<b>POLARIS</b>			<h1>TECHNICAL SERVICE BULLETIN</h1>		
Date: March 21, 2017		<h2>ATV</h2>		Bulletin Number: A-17-01-D Model Years: 2015 - 2016	
<input checked="" type="checkbox"/> <b>Safety Bulletin</b>		<input type="checkbox"/> Service Bulletin		<input type="checkbox"/> Service Alert Fax	
Distribution: <input type="checkbox"/> Owner/Principal <input type="checkbox"/> Service Manager <input type="checkbox"/> Sales Manager <input type="checkbox"/> Parts Manager <input type="checkbox"/> Technicians <i>This Service Bulletin is located at <a href="http://www.polarisdealers.com">www.polarisdealers.com</a></i> <small>-Confidential and Proprietary-</small>

**2015–2016 Sportsman 1000 1-Up Thermal Protection Update**

Some model year 2015–2016 Sportsman 1000 1-Up models were manufactured with an exhaust manifold side panel that may contact the exhaust manifold. The resulting contact between the exhaust manifold side panel and exhaust may pose a fire hazard.

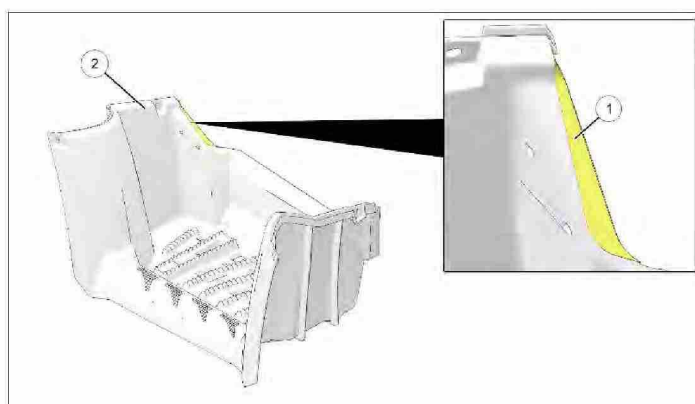
2. Place the provided template ① on the right-hand footwell ② as shown, then mark the perimeter of the template to outline the area to be trimmed with a paint pen.

Use the inside and back edges of the footwell to locate the template.

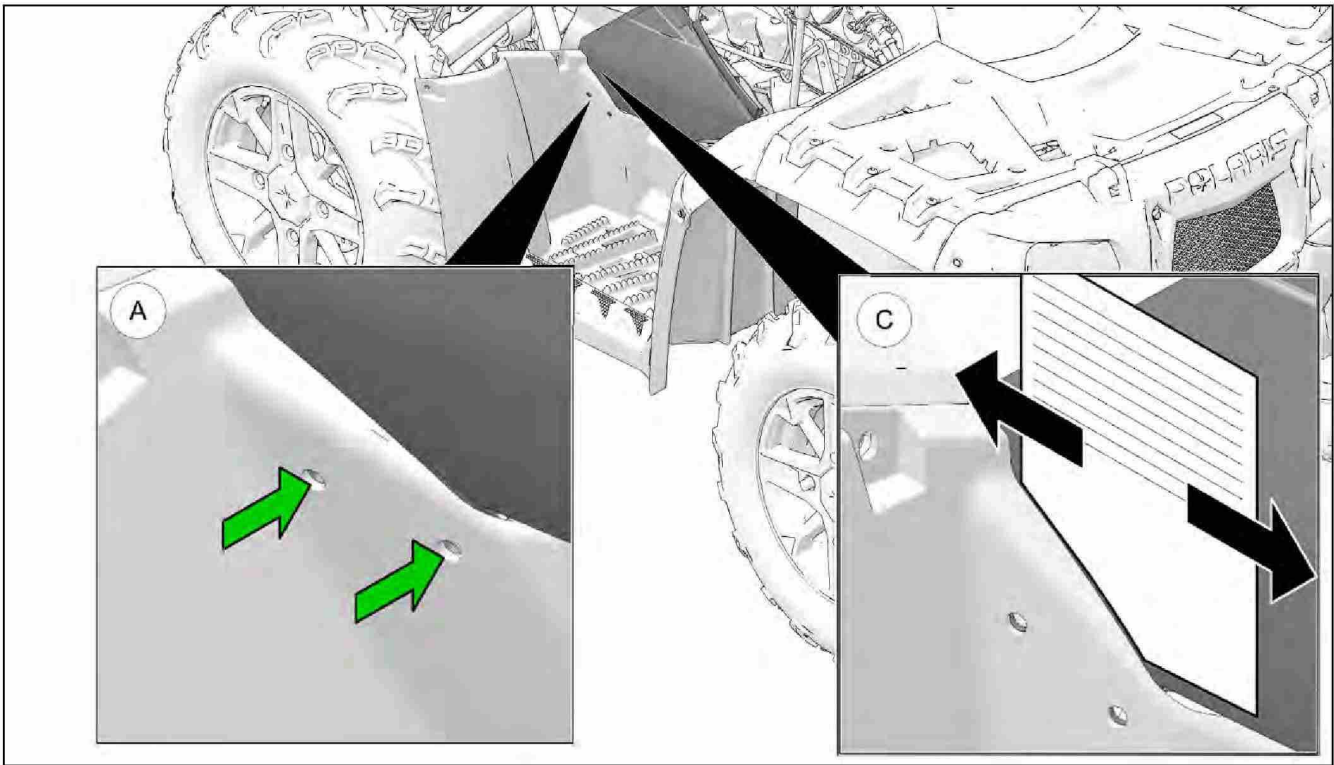
5. Using a DREMEL® with a two flute bit intended for plastics, a reciprocating saw or similar device, trim the footwell corner in line with the template (area circled in red shown in the **Before** and **After** images below).

6. Test fit the new panel to verify the footwell area trimmed does not contact the exhaust manifold side panel when the lower mounting surface is contacting the footwell.
  - A. Align the mounting holes.
  - B. Press the exhaust manifold side panel against the footwell applying pressure at or near the holes.
  - C. Slide a piece of paper along the gap between the two panels.
    - If the paper slows or stops or the metal shield makes contact with the footwell, use a half-round file to trim the footwell to create a clearance gap between the components.
    - If the paper freely travels the length of the gap, and the metal shield does not contact the footwell, proceed to the audit and following steps.

A secondary dealer representative must verify that the trimmed edge of the footwell does not contact the new exhaust manifold side panel.

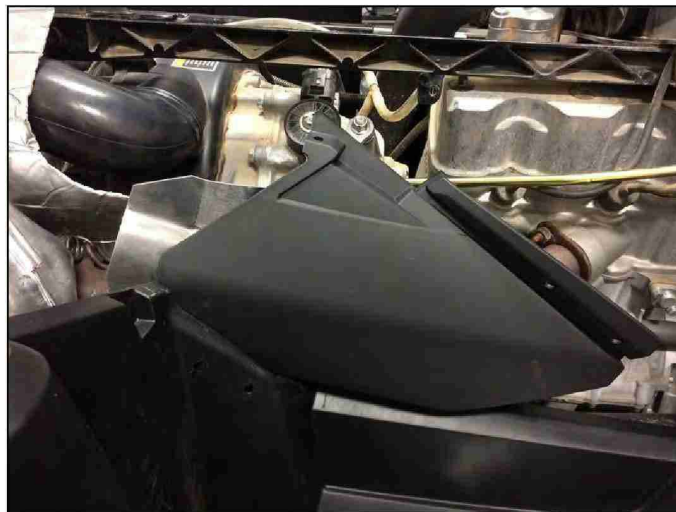
7. Pull the upper rear of the footwell towards the right side of the vehicle, then slide the NEW exhaust manifold side panel (2636626) along the head pipe and release the footwell.

A secondary dealer representative must verify the new exhaust manifold side panel (2636626) has been installed and the original exhaust manifold side panel has been discarded.

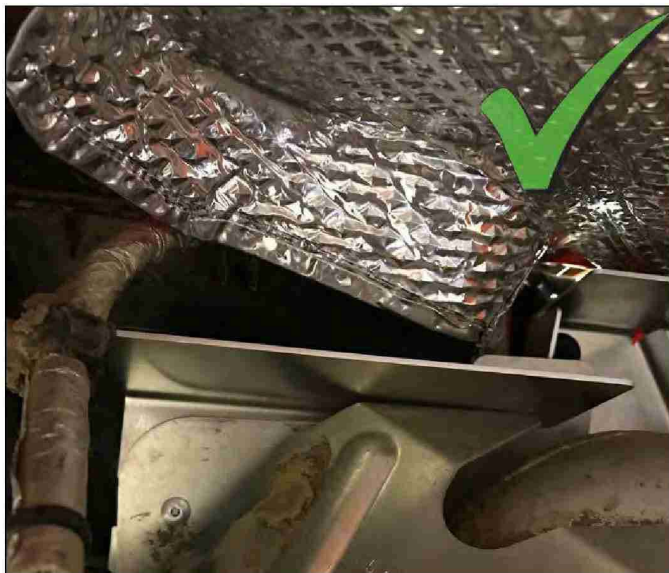
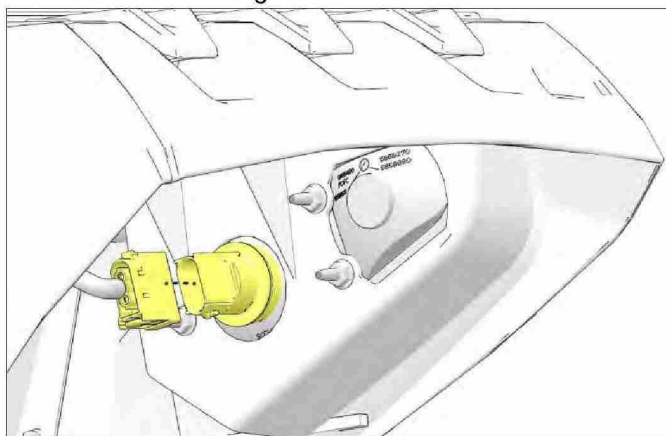
A secondary dealer representative must verify the Rear Cab Heat Shield is bent down and wraps around the corner of the Storage Box and Tail Light Harness. If it interferes when installing the cab, ensure it is bent back down to match the good example below.

Acceptable – Rear Cab Heat Shield encloses the corner of the storage box and harness

Unacceptable – Rear Cab Heat Shield interferes with the storage box and harness

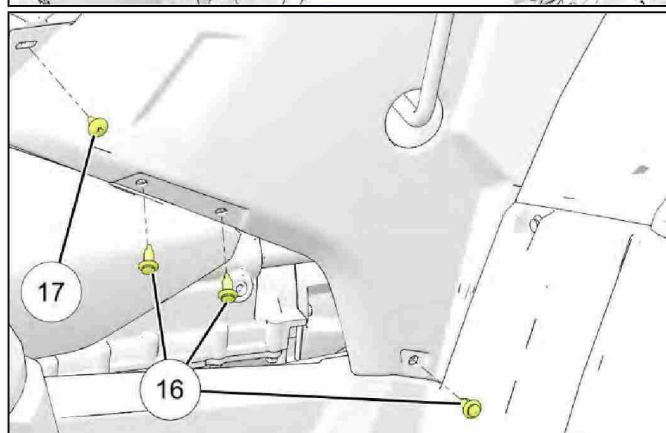
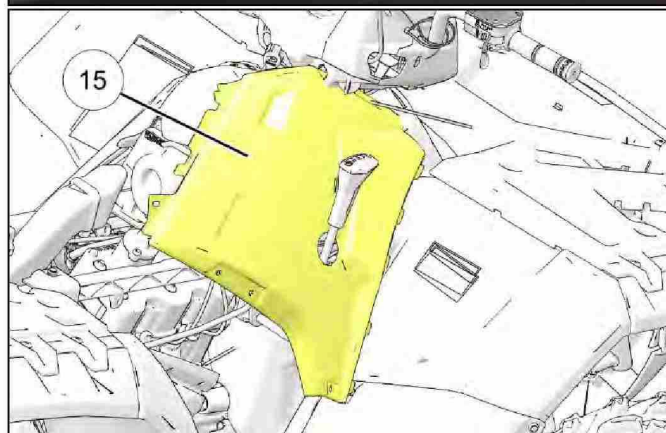
Verify the NEW exhaust manifold side panel tab is on top of the tab on the front cab heat shield as shown.

**PHOTO 1 - 1000 1-UP - New Thermal Protection Foils**

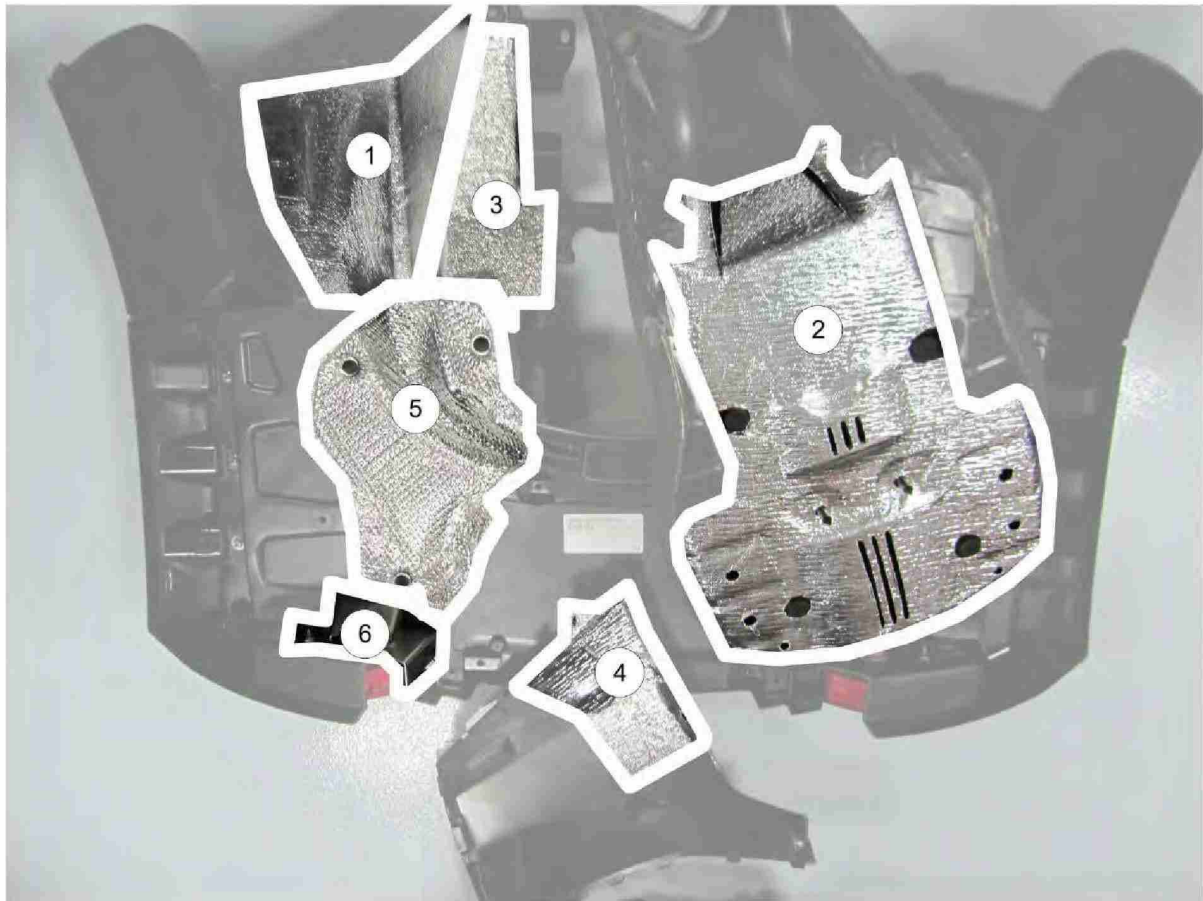
① Existing Rear Cab Foil	<b>DO NOT REMOVE!</b>
② Seat Heat Shield Foil	5814630
③ Rear Cab Heat Shield Foil	5814631
④ Side Panel Heat Shield Foil	5814632
⑤ Rear Cab Heat Shield	5263209
⑥ Tail Light Heat Shield	5264567

**PHOTO 2 - 1000 1-UP - New Heat Shields**

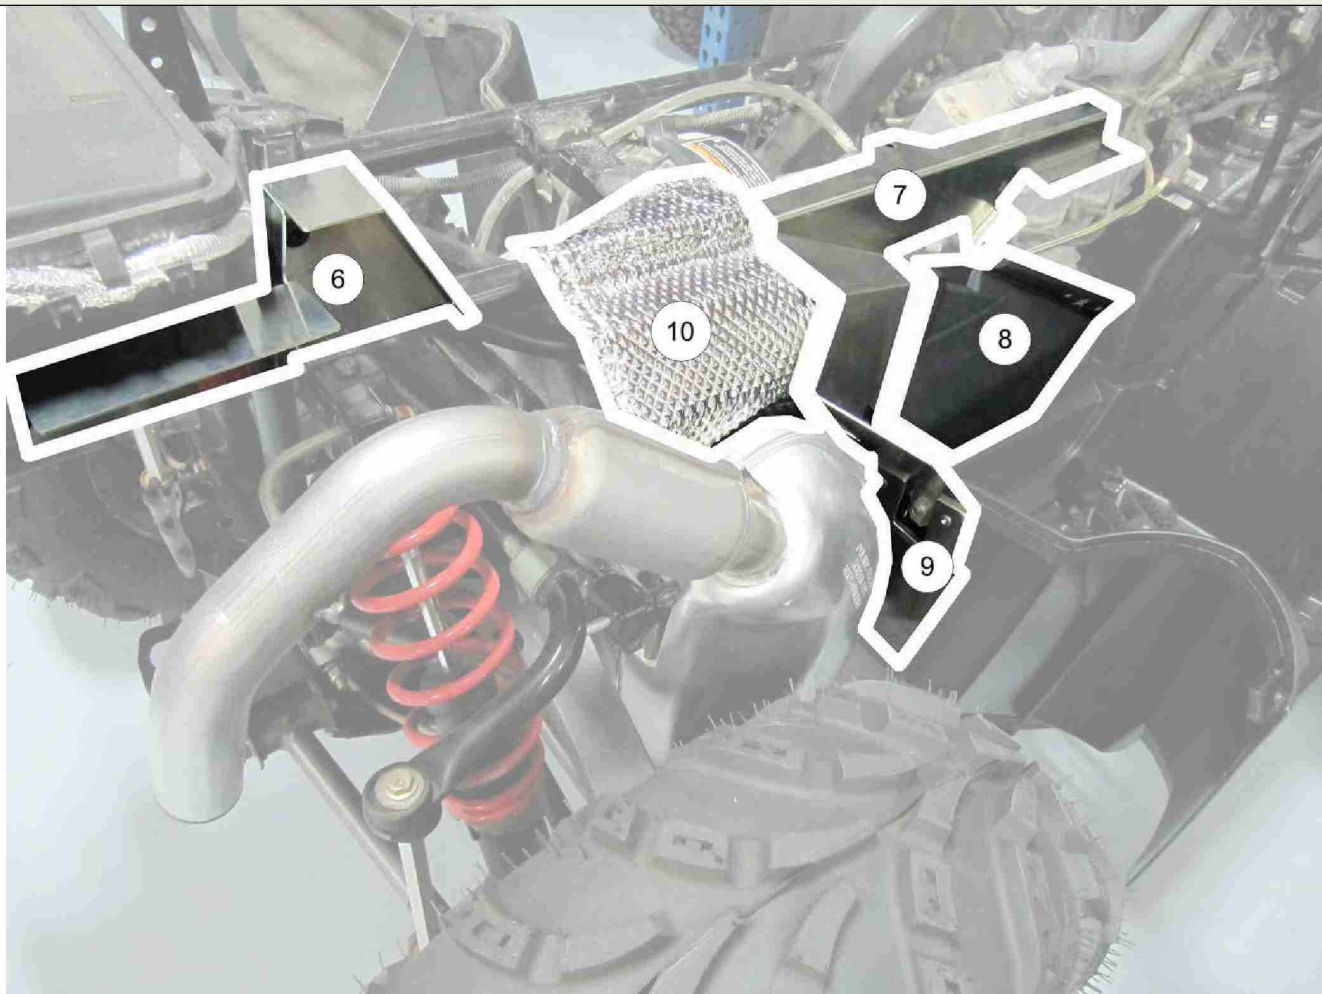
⑥ Rack Support Heat Shield	5264561
⑦ Front Cab Heat Shield	5264561
⑧ Exhaust Manifold Side Panel	2636626
⑨ Footwell Heat Shield	5264564
⑩ Clutch Duct Heat Shield	5264700
